Service Bulletin

Bulletin No.: 01-06-01-029A

Subject: Higher than Expected Engine Oil Consumption (Replace PCV Valve)

Models: 1999-2002 Chevrolet and GMC C/K Models

PCV Valve Identification

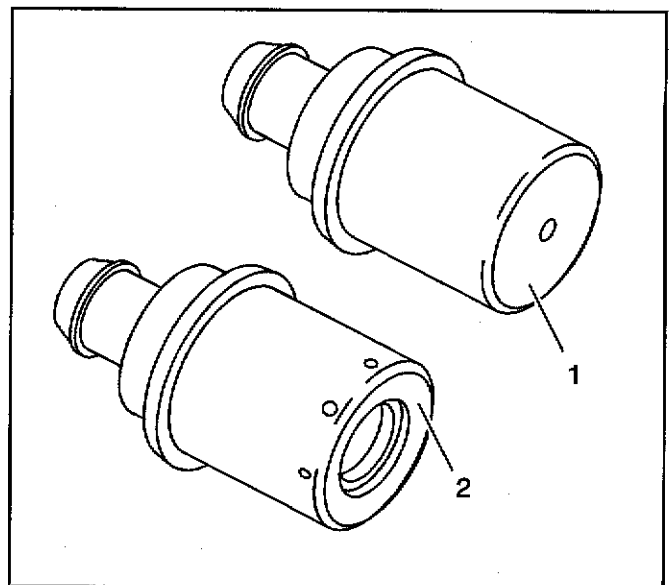
The condition may be due to the positive crankcase ventilation (PCV) valve flow rate under certain engine operating conditions.

1. Verify that the oil consumption is not the result of an oil leak or other engine concern.
2. The dealer should perform an oil consumption test. The vehicle should have accumulated over 6,450 km (4,000 mi) before establishing the oil consumption rate. Reference Corporate Bulletin Number 01-06-01-011, Information on Engine Oil Consumption Guideline, for details.
3. Remove the PCV valve and inspect the hose going to the intake manifold for signs of excessive oil being present.
4. If excessive oil is present in the PCV hose, replace the PCV valve (Type 948C) (2) with a new-style fixed orifice PCV valve (Type CV2001-C) (1). See the illustration below.

- (1) New style fixed orifice PCV Valve (Type CV2001-C)
- (2) Spring and plunger style PCV Valve (Type 948-C)

Important: The new style fixed orifice PCV valve contains no moving parts, and does not rattle when shaken.

If the vehicle has an orifice style PCV valve, investigate other causes for high oil consumption.
